ARCHITECTURAL REVIEW BOARD STAFF REPORT

Project #/Name	SP-2023-21: Flow Hyundai Outdoor Storage, Display, and Sales
Review Type	Advisory Review for a Special Use Permit
Parcel Identification	04500-00-00-068C0
Location	On the west side of Rt. 29, approximately 1280' south of the Rt. 29/Hilton Heights Rd. intersection.
Zoned	Highway Commercial (HC) / Entrance Corridor (EC) / Airport Impact Area (AIA)
Owner/Applicant	TAP Investments LLC / Shimp Engineering (Kelsey Schlein)
Magisterial District	Rio
Proposal	To establish outdoor storage, display, and sales of vehicles in association with the construction of an auto dealership consisting of two showrooms with service bays and associated site improvements on approximately 5.72 acres.
Context	The property is vacant and mostly wooded. The east and west perimeters of the parcel are bounded by Rt. 29 and Berkmar Drive with automobile dealerships to the north and south of the subject property. (Fig. 1.)

Figure 2: Proposed concept plan showing the layout of buildings, travelways, vehicle storage and display areas, and parking.

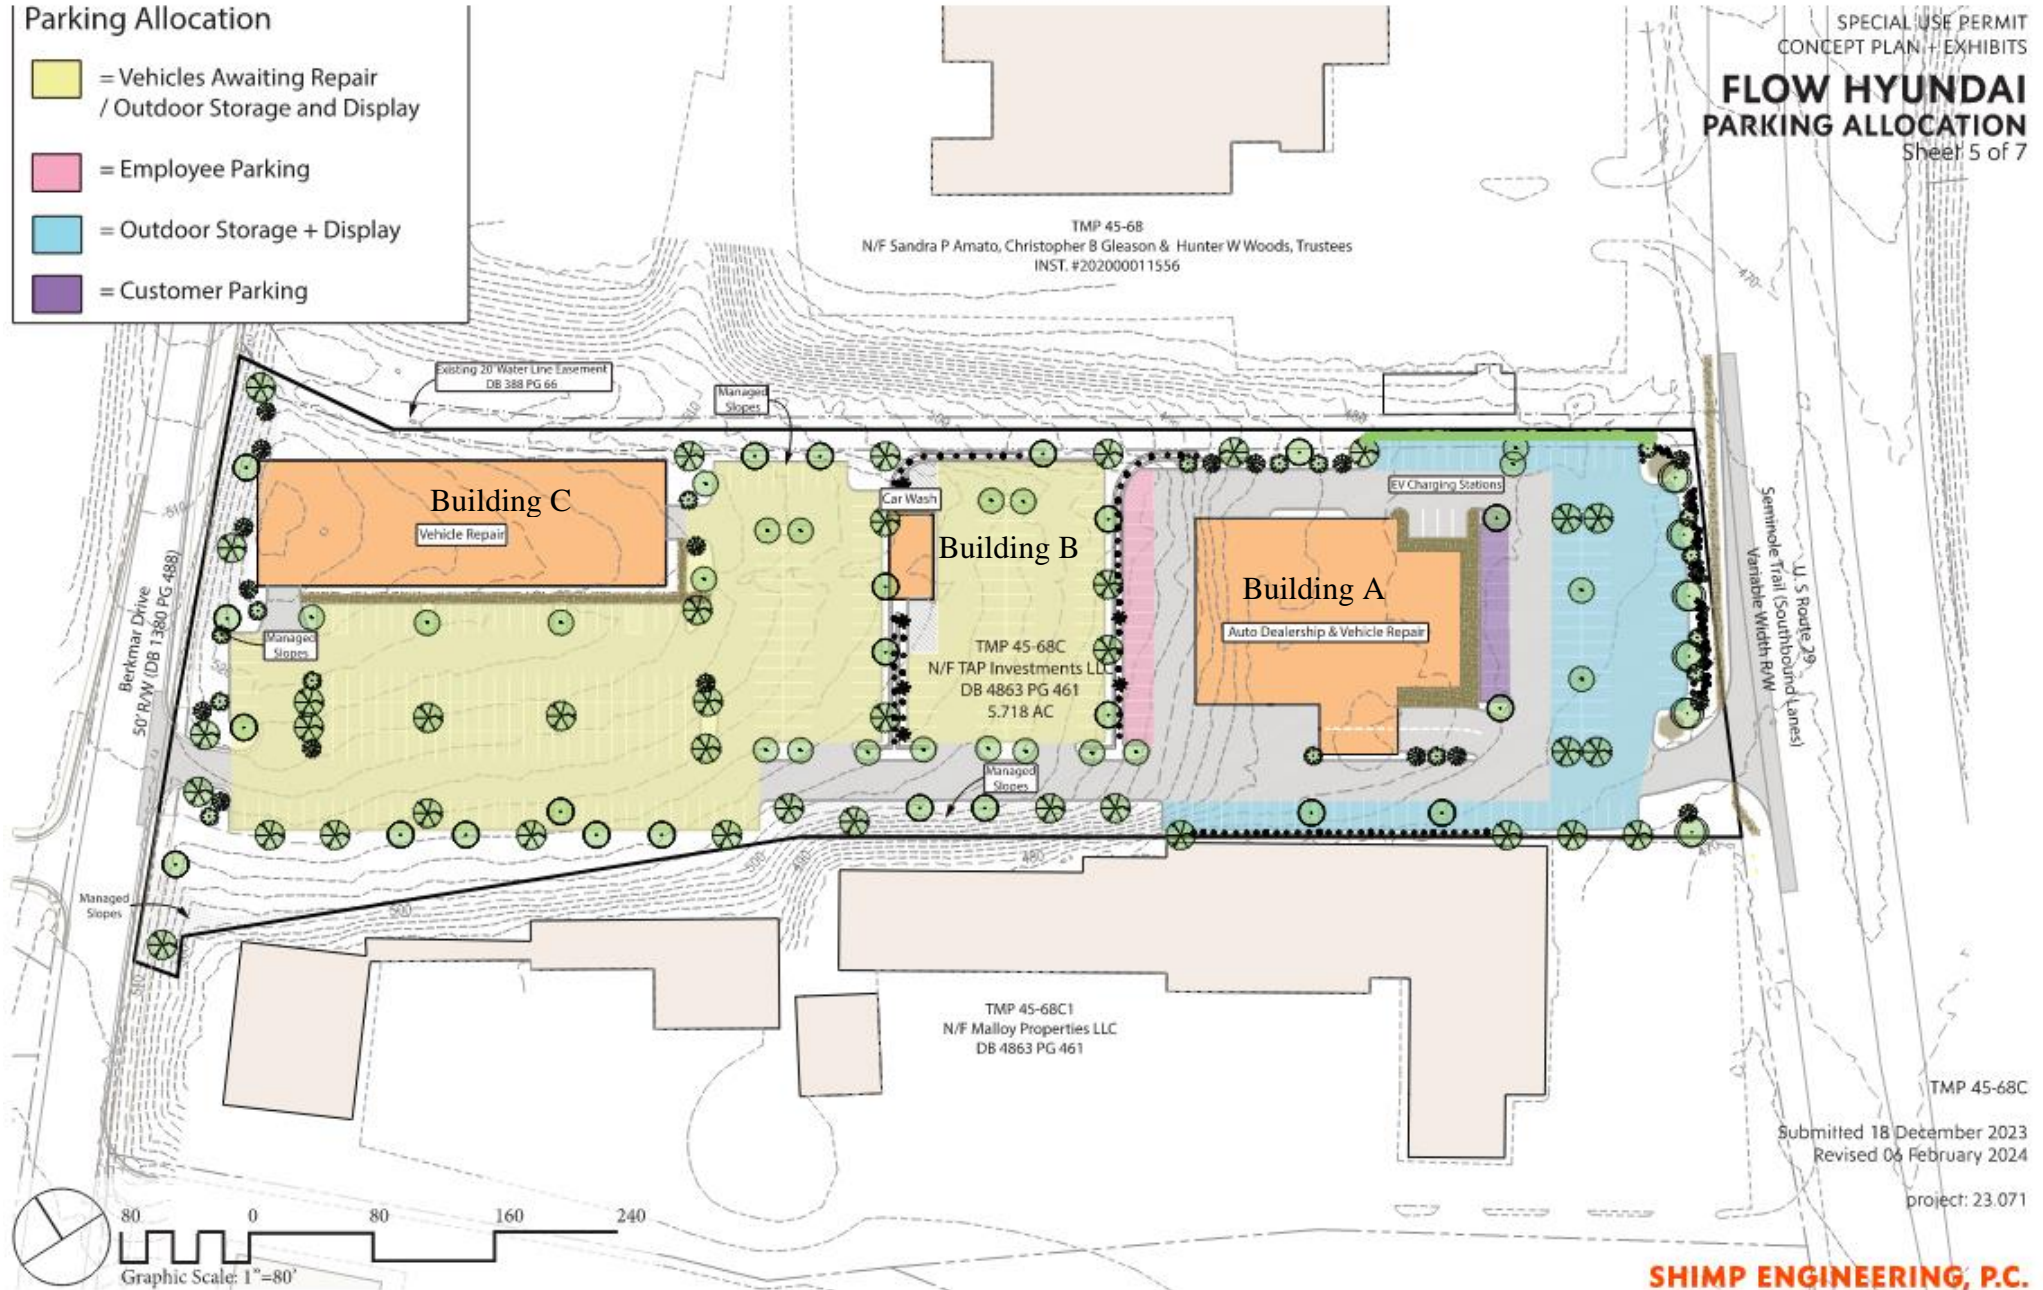
<p>maintain the health of the tree and shall be protected by curbing.</p> <p>c. Shrubs should be provided as necessary to minimize the parking area's impact on Entrance Corridor streets. Shrubs should measure 24 inches in height.</p>	<p>the parking schedule, but the total number of spaces shown on the site plan far exceeds that amount, and details have not been provided on tree species and planting size. Also, the interior trees are mostly distributed throughout the western portion of the site, which provides less benefit to the EC.</p> <p>The plan designates some of the parking spaces for outdoor storage, display, and sales. That use requires a Special Use Permit in the Entrance Corridor overlay. Historically, landscaping beyond the minimum requirements has been one effective method of offsetting impacts from the storage/display/sales use. The current plan does not meet minimum landscape requirements and does not appear to offer opportunities for establishing other mitigation measures in the areas of the site closest to the EC. For these reasons, staff cannot recommend approval of the initial site plan.</p>	<p>Increase the number of interior trees in the parking areas near Building A.</p>	<p>likely too narrow to accommodate the trees shown there.</p> <p>The concept plan shows some additional measures to mitigate the visual impact of the storage and display parking visible from the EC (Fig. 2). The frontage planting area has increased minimally, six interior trees have been added at the EC end of the site, and an increased number of ornamentals and shrubs are shown interspersed among the frontage trees. However, the interior trees along the north and south sides of the site are also attempting to satisfy perimeter parking area landscaping requirements, and little landscaping is shown in the area south of the site entrance along Rt. 29. Providing additional landscaping north and south of the showroom building and south of the Rt. 29 site entrance may help to better satisfy both frontage and perimeter and interior parking area landscaping requirements.</p> <p>A parking schedule has not been included in the concept plan.</p>

1. The extent to which proposed landscaping mitigates the visual impacts of the storage, display and sales parking.
 - a. The depth of the planting area along Rt. 29.
 - b. Landscaping along parking lot perimeters.
 - c. Distribution of interior parking lot trees.

1. Revise the concept plan to show the easements and show that there are no conflicts.
2. Revise the concept plan to show increased landscaping south of the site entrance along Rt. 29.
3. Revise the concept plan to provide additional tree islands in the northern and southern parking rows at 40’ on center.
